THIRD NOTICE OF DEFICIENCY FOR THE EXIDE TECHNOLOGIES, VERNON FACILITY PART B PERMIT APPLICATION, REVISION 7 PREPARED BY ADVANCED GEOSERVICES CORPORATION, DATED JANUARY 2013, U.S. EPA ID NUMBER CAD 097854541

SUBJECT: REVIEW OF THE CLOSURE AND POST CLOSURE
CARE COST ESTIMATE FOR PERMIT RENEWAL AND
BANKRUPTCY COURT CLAIM, EXIDE TECHNOLOGIES,
VERNON, CALIFORNIA, SITE CODE 300214

SUBJECT: Review of Section 12 (Closure Plan) of the Part B
Application, Revision 7
Exide Technologies, Inc. Site
2700 South Indiana Street
Vernon, California 90058
Prepared by Advanced Geoservices Corp. (AGC)

**Reverb Furnace Feed Room, Corridor, and Blast Feed Room
(Containment Building)**

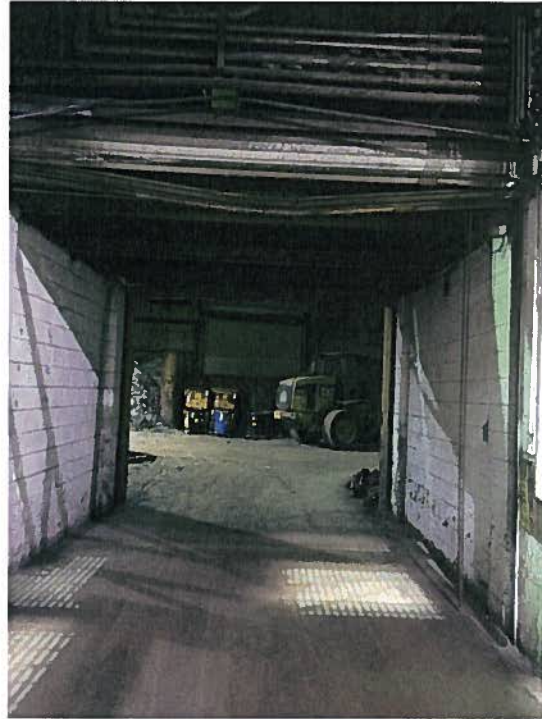
4. During a **site inspection** DTSC staff found: gross contamination of the buildings and subsurface drainage systems, evidence of spills inside the containment buildings on the concrete floor and running out from spaces under the containment building doors, and corrosion and cracking of the metal and cement structures as shown in the following photographs and photographs included in Attachment A.

Based on these observations DTSC staff determined that demolition of the buildings and removal of at least five feet of contaminated soil under the buildings would be necessary for the closure of the facility pursuant to 22 CCR 66264.112(b)(4). The Closure Plan and Cost Estimate shall be revised to include the demolition and disposal of the structures using the current costs provided in the following detailed comments, unless sample results indicate the soil is clean and the structures can be decontaminated and certified by a California Structural Engineer to be able to withstand the Maximum Considered Earthquake.
